#### **Airworthiness Directives; Boeing Model 747-400 Series Airplanes Equipped With General Electric Model CF6-80C2 Series Engines**

**ACTION:** Notice of proposed rulemaking (NPRM).

**Boeing:** Docket 2002–NM–128–AD.  
Supersedes AD 2000–09–03,  
Amendment 39–11711.

**Electro-Mechanical Brake and CDU Cone Brake Torque Check  
Figure 1**

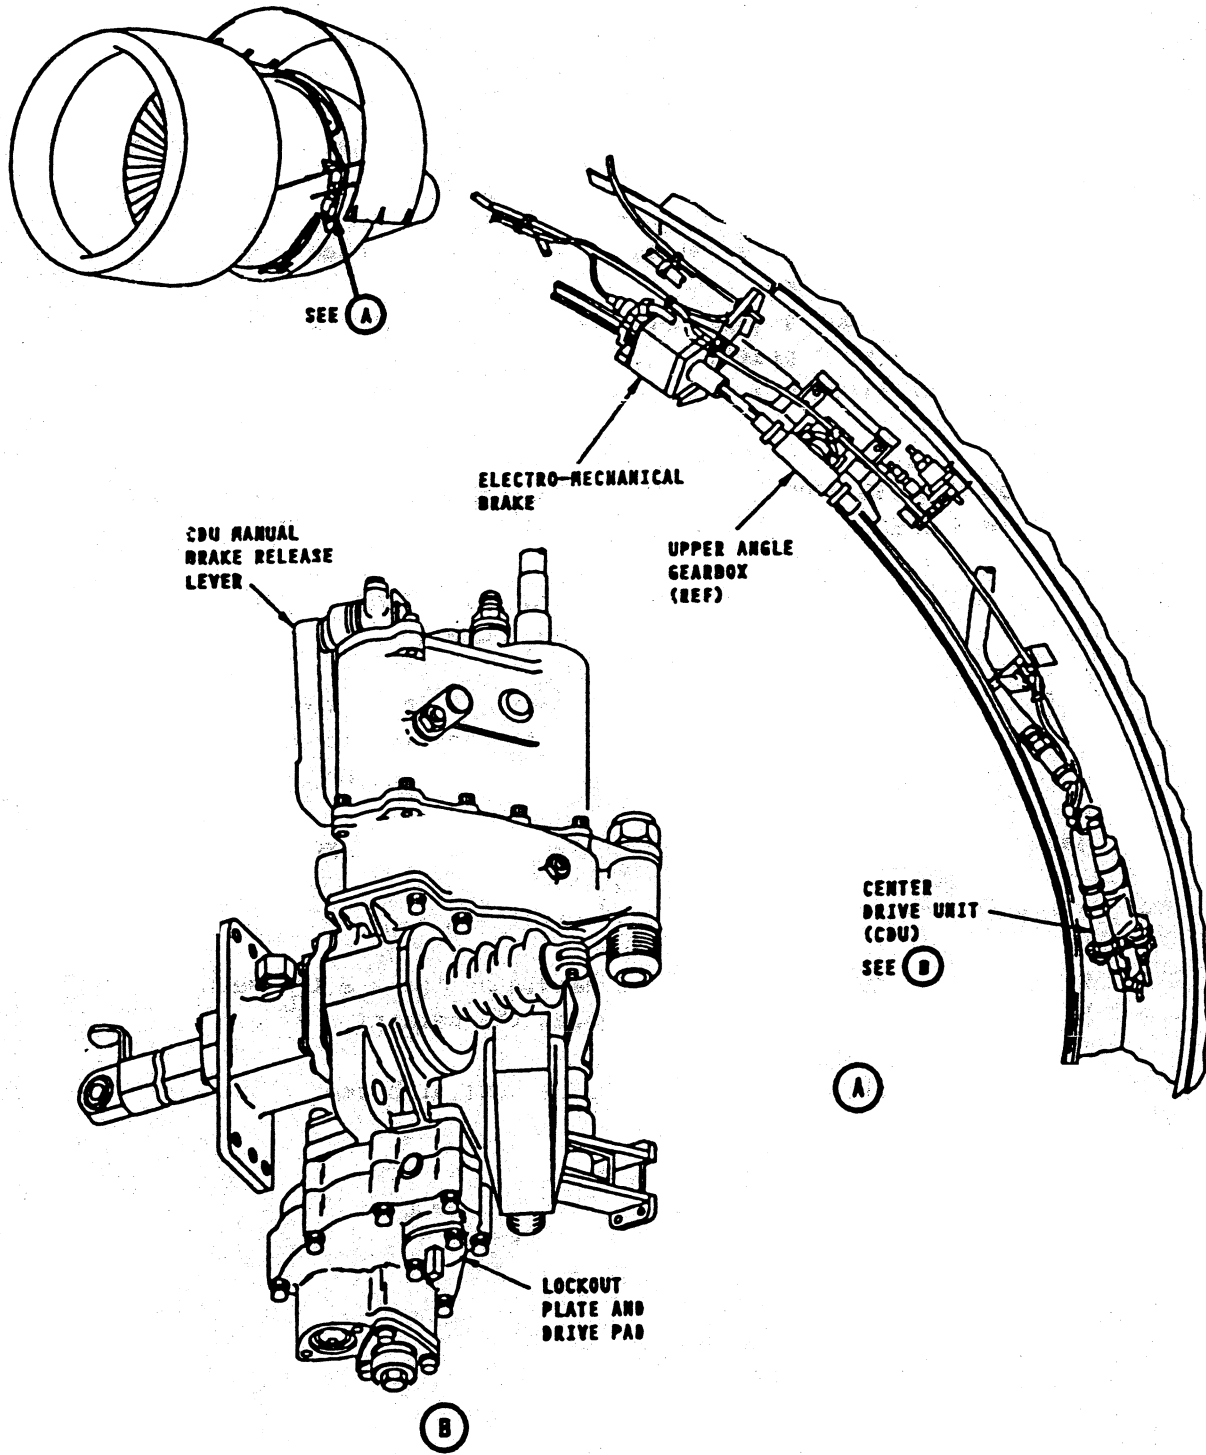
2. CDU cone brake check (Figure 1):

(6) Install a ¼-inch drive and a dial-type torque wrench into the CDU drive pad.

**Caution:** Do not use more than 100 pound-inches of torque when you do this check. Excessive torque will damage the CDU.

(7) Turn the torque wrench to try to manually extend the translating cowl until you get at least 15 pound-inches.

**Note:** The cone brake prevents movement in the extend direction only. If you try to measure the holding torque in the retract direction, you will get a false reading.

(8) If the torque is less than 15 pound-inches, you must replace the CDU.
